Office Action Summary

10/689,838

DIECKMANN, VOLKER

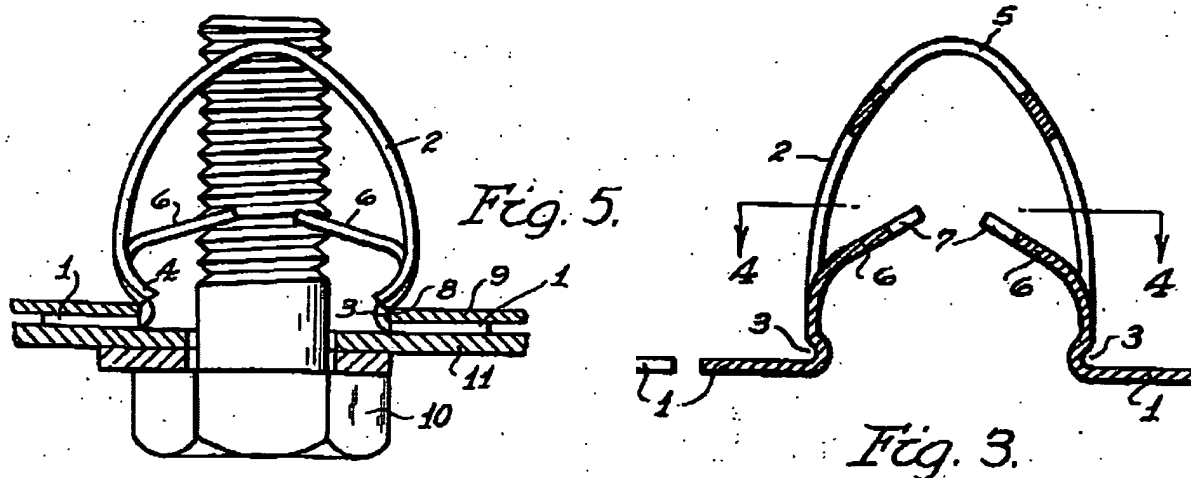
Further Re claim 4: said at least one supporting part includes a tubular rail drawn out of the spring bottom and wherein the walls are curved from said recess to said arched bottom. A prong is considered a rail:

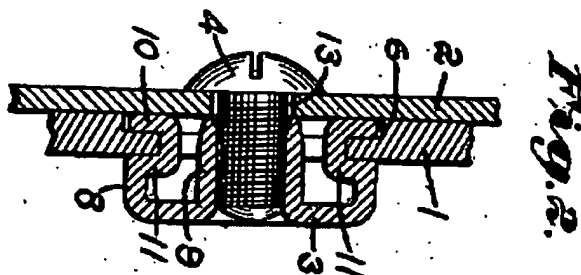
5. Claims 3-4 and 7-8 are rejected under 35 U.S.C. 102(b) as being anticipated by Meyer USP 3869760. Meyer teaches a clamping piece (Fig 1,2 and 3) of springy sheet metal col 2 lines 25-29) comprising 2 opposing arms, each arm having a v-shaped latching recess functionable as described, an arched shaped spring bottom connecting said opposing arms, said spring bottom having a hole in its middle for a screw, and at least one supporting part (26) capable of positioning between spring bottom and mounted component capable of holding the spring bottom a minimum distance from the component when pressure is applied on the spring bottom. The structure is clearly shown in the figures.

Further Re claim 3: said at least one supporting part (26) comprising a portion of one of said arms that extends at an angle to the respective one of the latching recesses towards spring bottom.
